WW-P-471C
AMENDMENT 1
6 March 1987

FEDERAL SPECIFICATION

PIPE-FITTINGS: BUSHINGS, LOCKNUTS, AND PLUGS; IRON, STEEL, AND ALUMINUM: (THREADED); 125-150 POUNDS

This amendment forms a part of Federal Specification WW-P-471C, dated December 29, 1981, is approved by the Commissioner, Federal Supply Service, General Services Administration, for the use of all Federal Agencies.

Paragraph 1.2.2

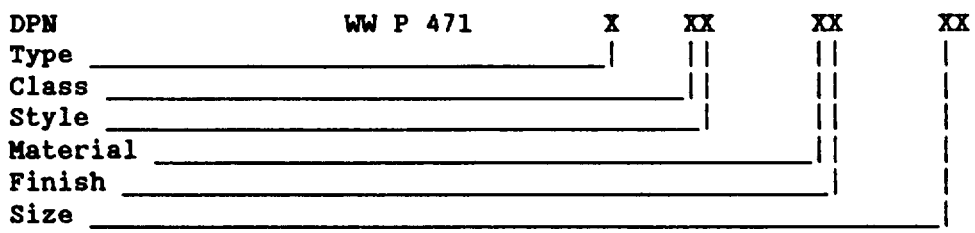
DELETE: In its entirety.

ADD: 1.2.2 Definitive part number (DPN). Plugs, bushings, and locknuts covered by this specification shall be identified by a DPN. This part number is intended for cataloging and ordering purpose only. The DPN shall consist of the Federal Specification symbol plus the specification part number (see 1.2.1). The DPN shall be written as follows (see 6.2):

NOTE: Use Q where class and style is not applicable.
